SUBMITTAL TO THE BOARD OF SUPERVISORS
COUNTY OF RIVERSIDE, STATE OF CALIFORNIA

SUBJECT: TRANSPORTATION AND LAND MANAGEMENT AGENCY/TRANSPORTATION:
Approve Addenda to the Plans and Specifications, Accept the Low Bid and Award the Contract for the Construction of Clark Street Resurfacing and Sidewalk Improvements Project in the Community of Mead Valley; District 1. [\$4,368,797 Total Cost - ARPA Funds 87%, Local Funds 13%] (4/5 Vote Required)

CLARK STREET
RESURFACING AND SIDEWALK
IMPROVEMENTS PROJECT

Item 7: Plan sheet revisions – Clark Street Resurfacing and Sidewalk Improvements Project

APPROVED BY: DATE: 08/02/24	TYPICAL CROSS SECTIONS SHEET No. CLARK STREET RESURFACING AND SIDEWALK IMPROVEMENTS X-1
	PREPARED BY: AECOM 999 TOWN & COUNTRY ROAD ORANGE, CA 92668

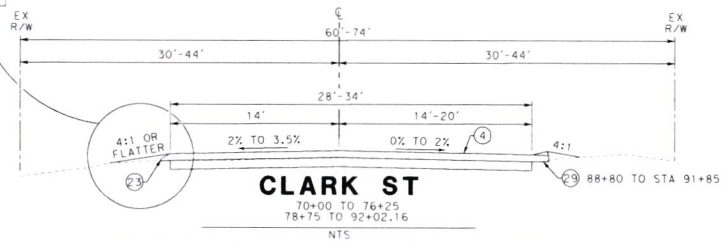
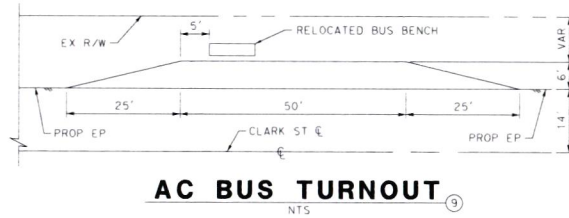
1. Sheet 1 of 39, T; abbreviations and legend revised
2. Sheet 2 of 39, X-1; construction notes revised and deleted
3. Sheet 3 of 39, P-1; driveway revised
4. Sheet 8 of 39, L-1; driveway revised
5. Sheet 21 of 39, C-7; driveway revised, construction notes revised, and removal notes added
6. Sheet 26 of 39, C-12; construction notes revised and deleted, removal notes added
7. Sheet 27 of 39, C-13; construction notes revised and deleted, removal notes added
8. Sheet 30 of 39, DG-1; driveway revised

1 REVISED PER ADDENDUM No. 1

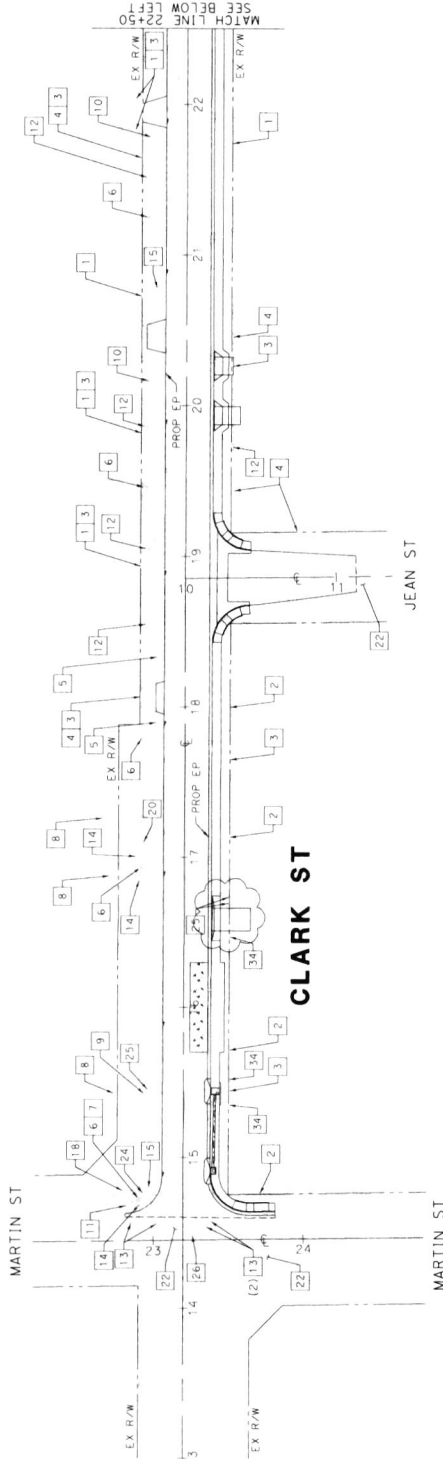
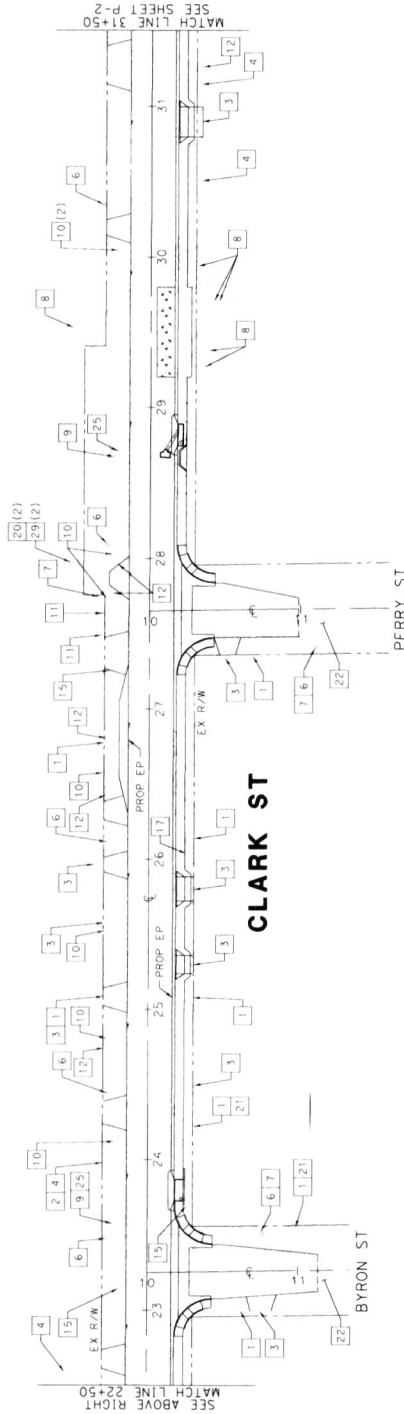
1 REVISED PER ADDENDUM No. 1

PLAN AND PROFILE SHEET NO. L-1

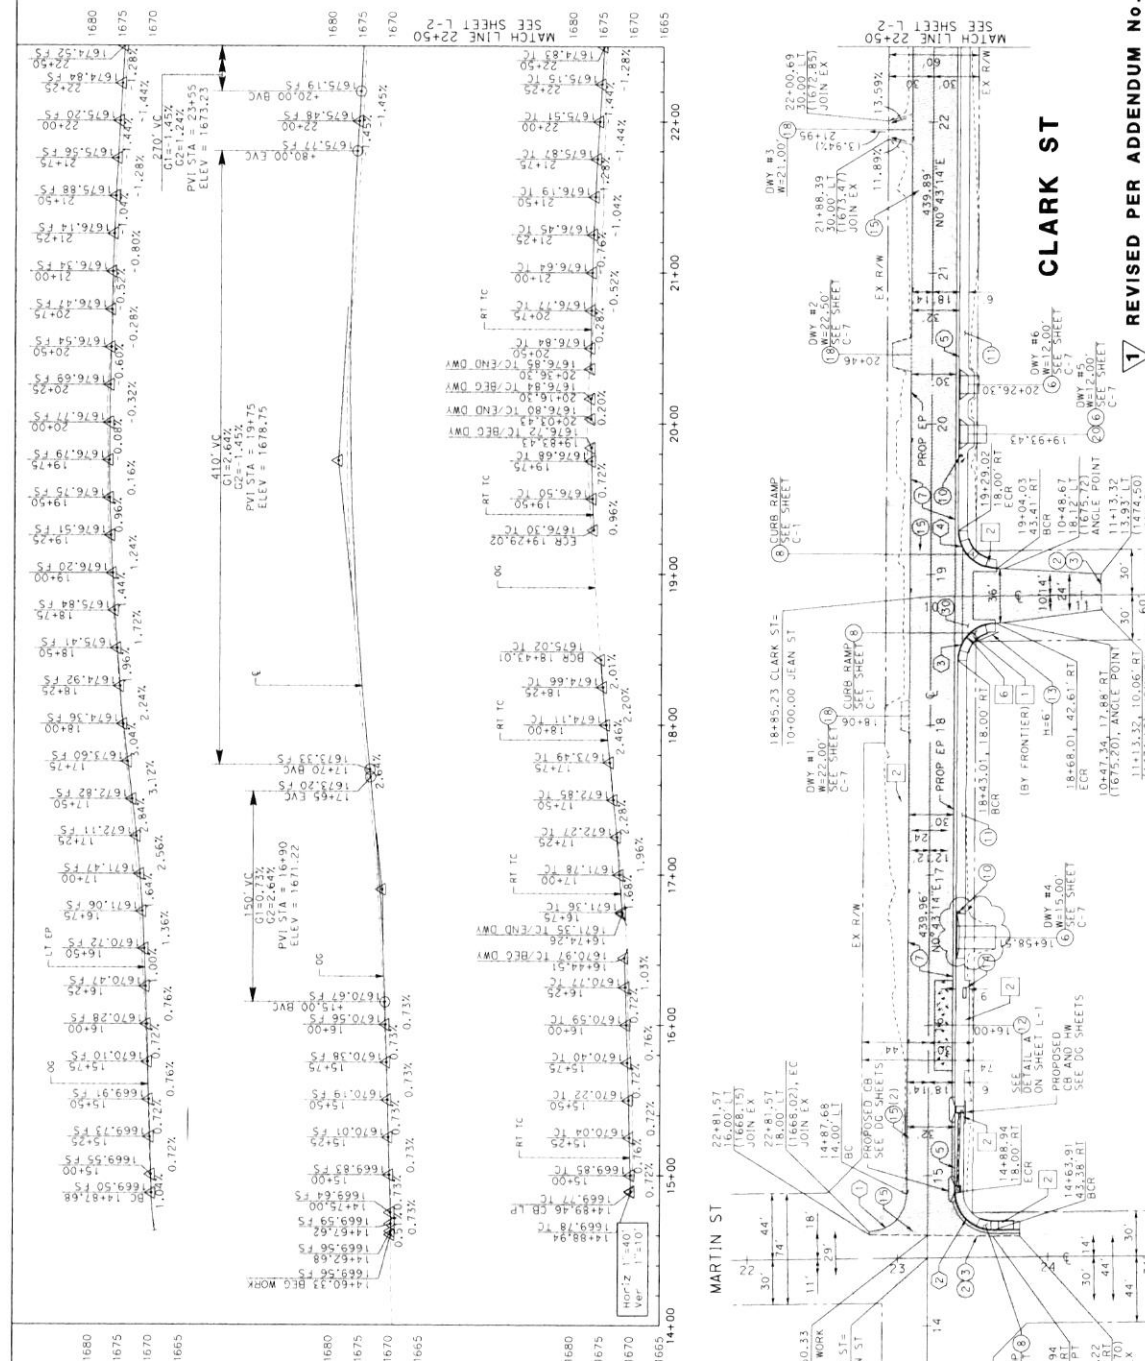
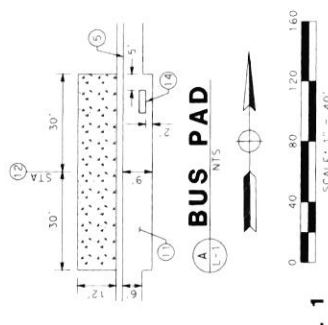
REVISOR PER APPENDUM NO. 1

C-13

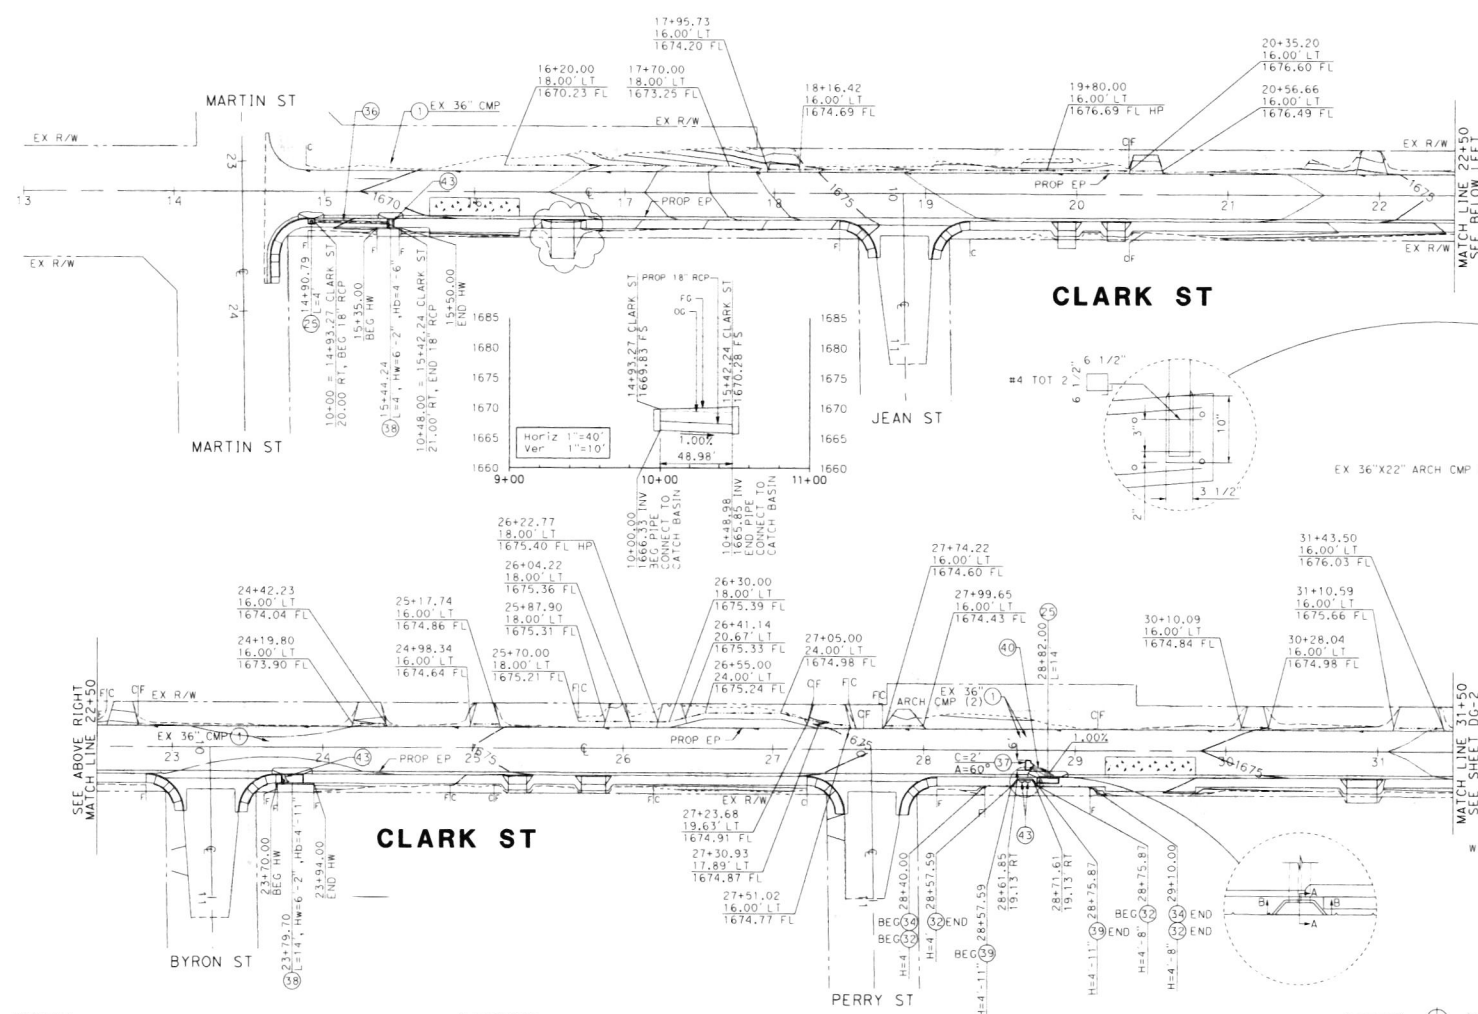
REVISED PER ADDENDUM No. 1

SHEET No. L-3

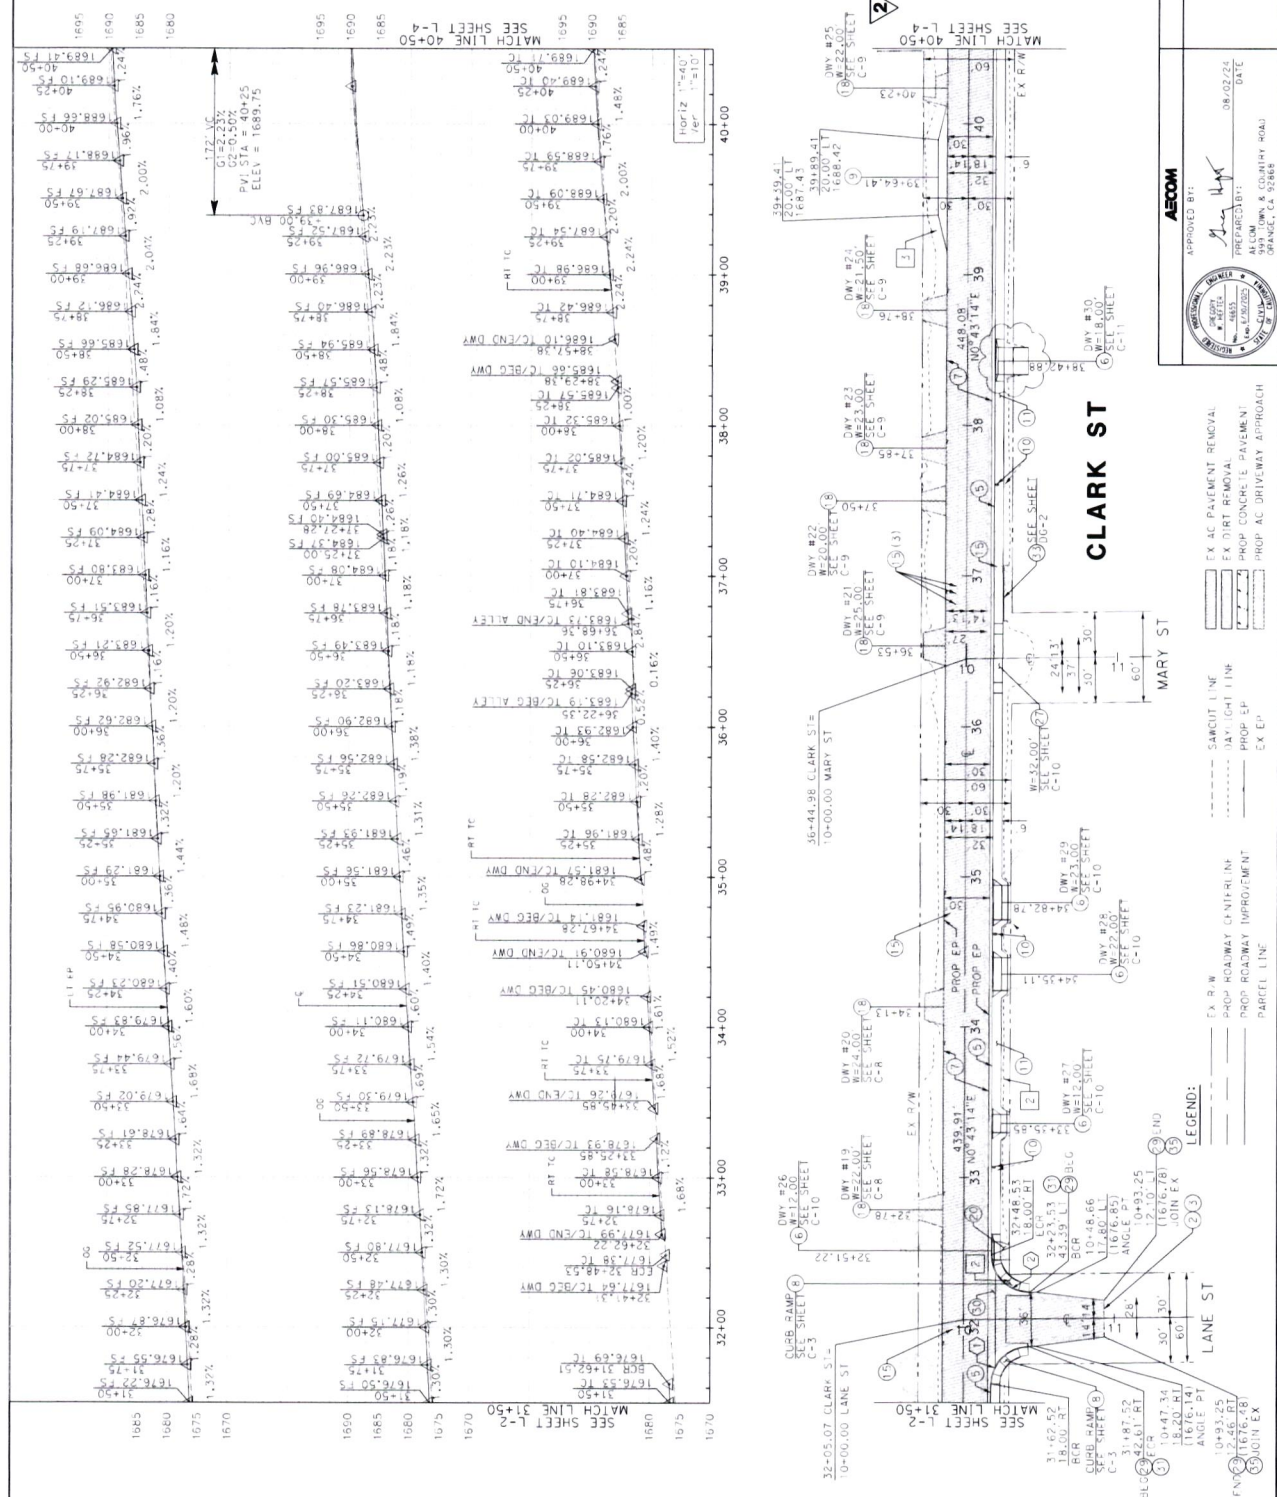
1. Sheet 10 of 39, L-3; driveway revised
2. Sheet 11 of 39, L-4; driveway revised
3. Sheet 21 of 39, C-7; fence work added, driveway revised, construction note added (Supersedes Sheet issued by Addendum No. 1)
4. Sheet 25 of 39, C-11; driveways revised, construction notes added, removal notes added
5. Sheet 31 of 39, DG-2; driveways revised

L-4

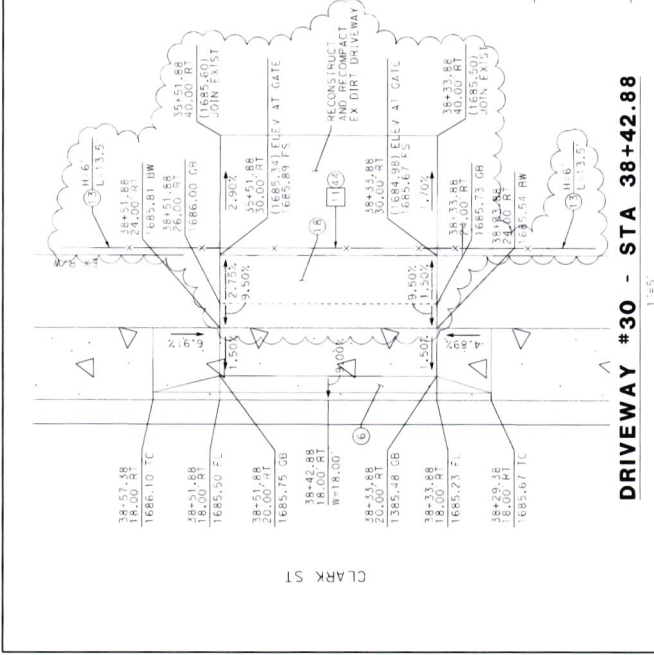
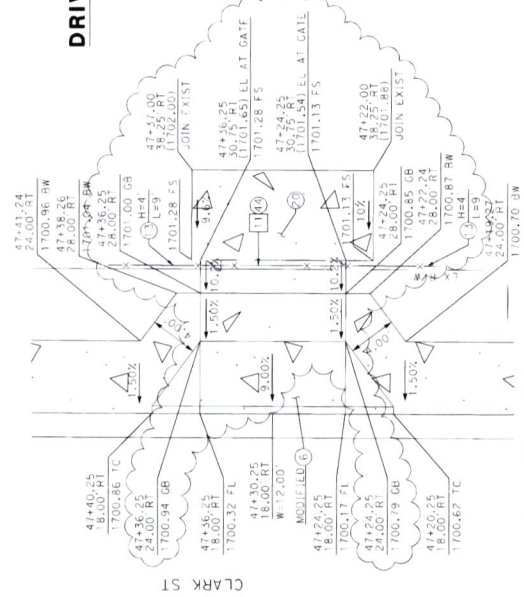
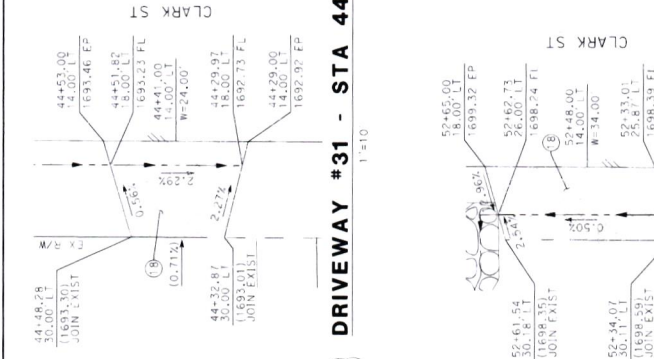
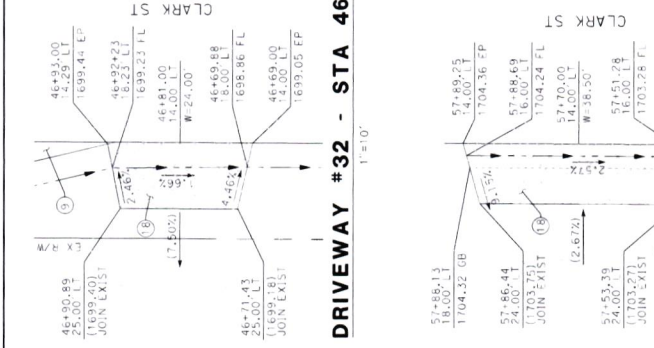
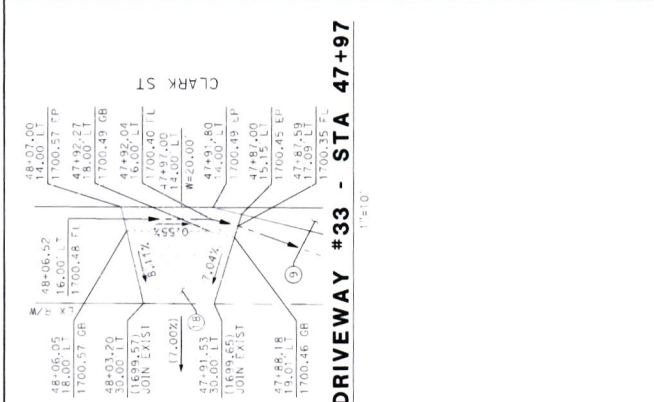
REVISIONS PER ADDENDUM No. 2

C-11

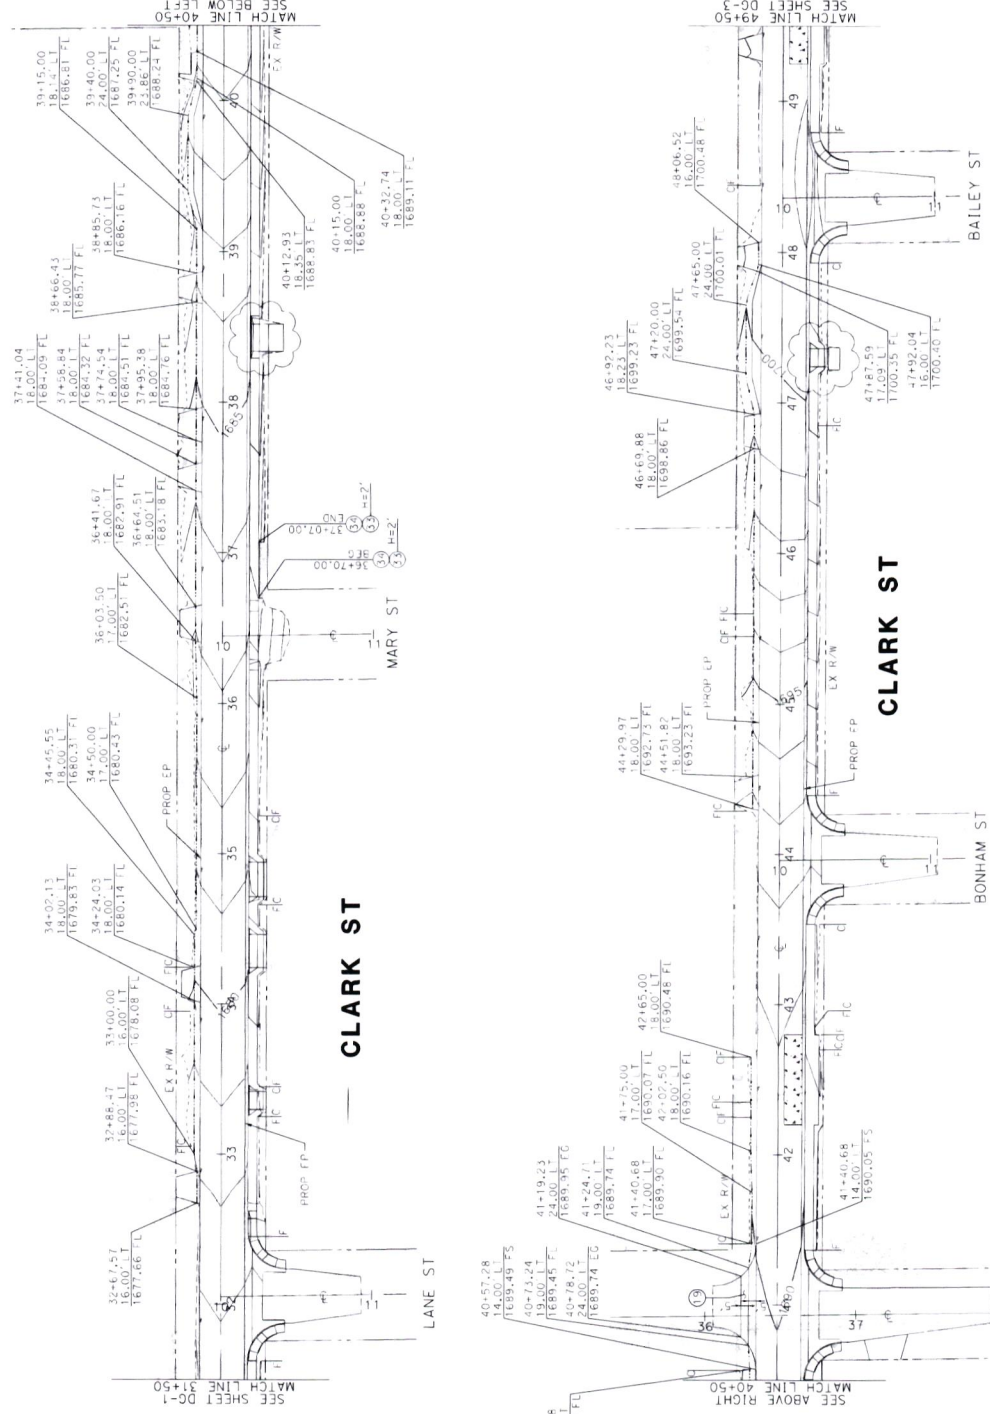
2 REVISED PER ADDENDUM No. 2
